RECEIPT DATE: 9-30-22 **ONSITE SEWAGE DISPOSAL SYSTEM**

APPROVAL DATE: 11/2/22 **PERMIT: CONSTRUCTION**

PROPERTY ADDRESS: 7001 COLT PLACE, DAYTON, MD 21036

**ONSITE SEWAGE DISPOSAL SYSTEM DESIGN PLAN**

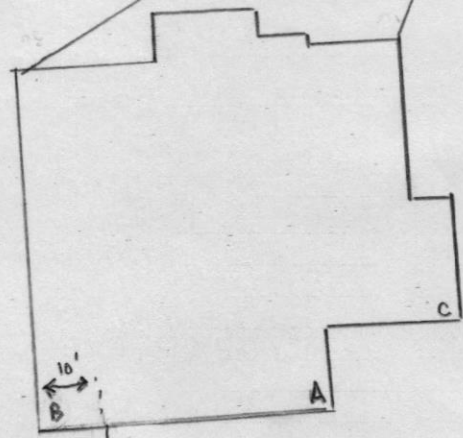
W NO TAG  
as of  
11/1/22

90'  
48'

ST - 52' to A  
20' to B

d box - 73' to A  
- 40' to B

62' to B  
38' to C

83'

WALLCHECK  
 LOT 25  
**WILLOWSHIRE**  
 LIBER 18479, FOLIO 296  
 PLAT NO. 25505  
 5th ELECTION DISTRICT  
 HOWARD COUNTY, MARYLAND

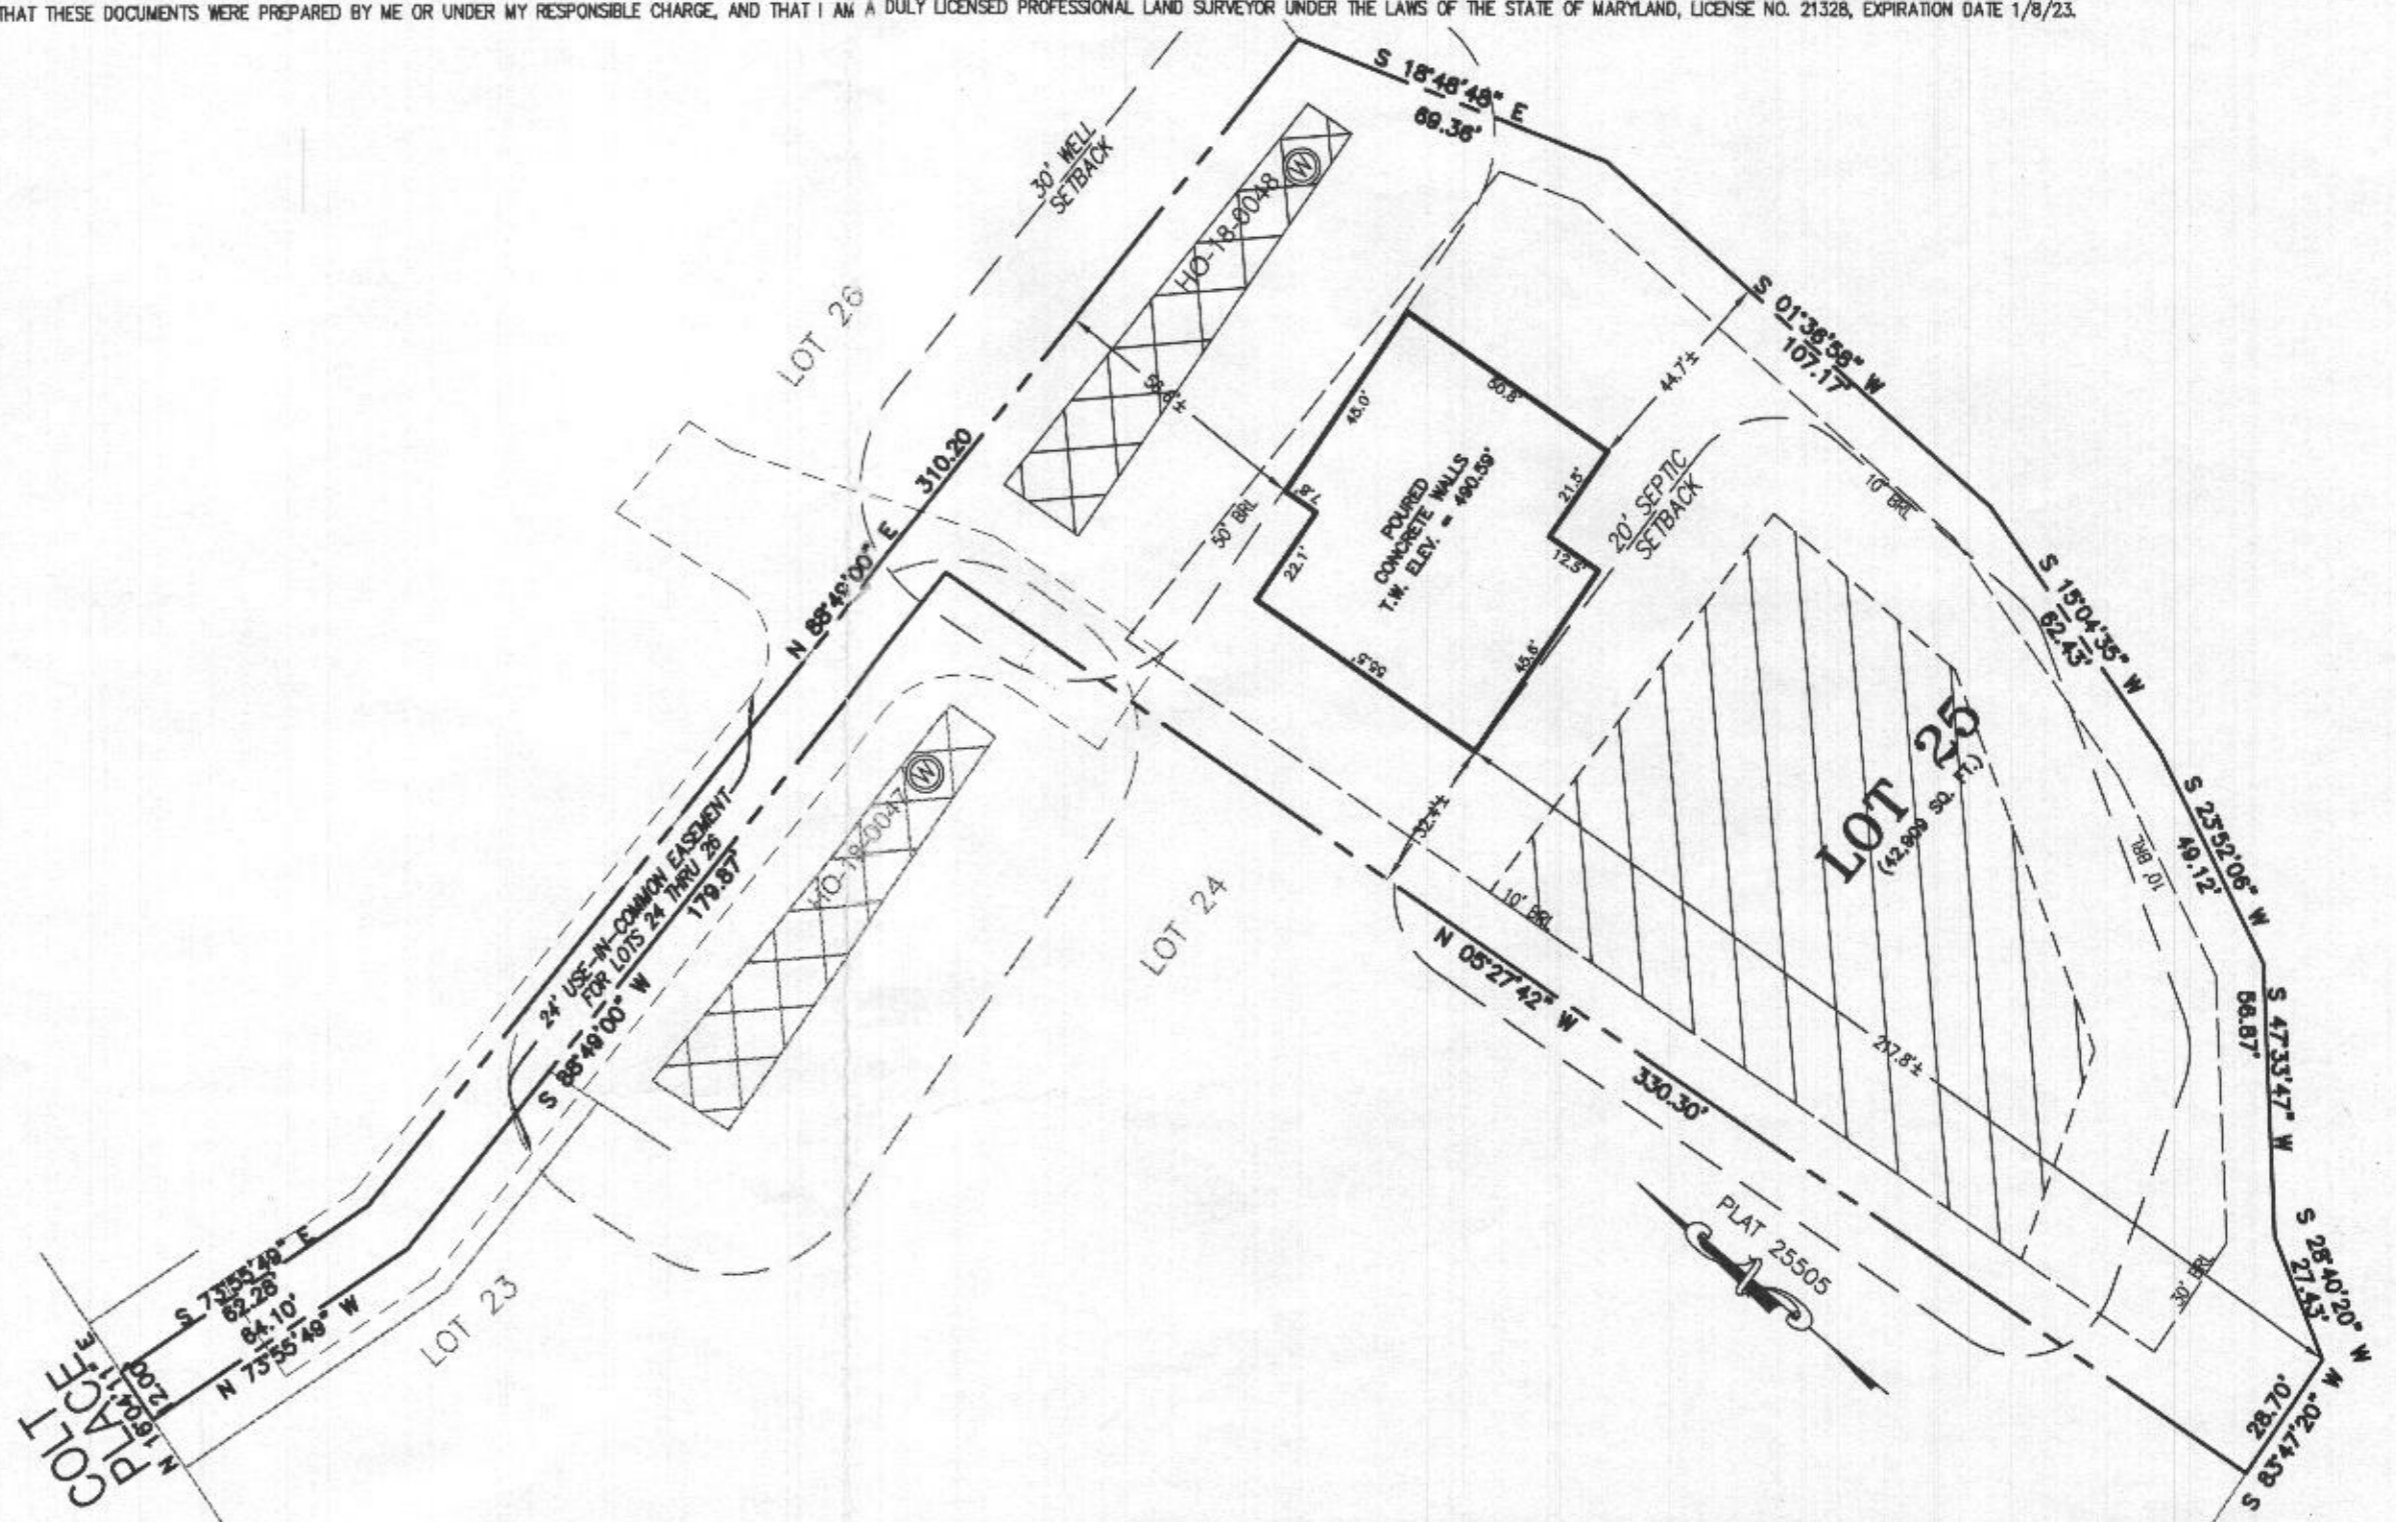
Foundation has changed.

Need new OSDS plan &  
new floor plans.
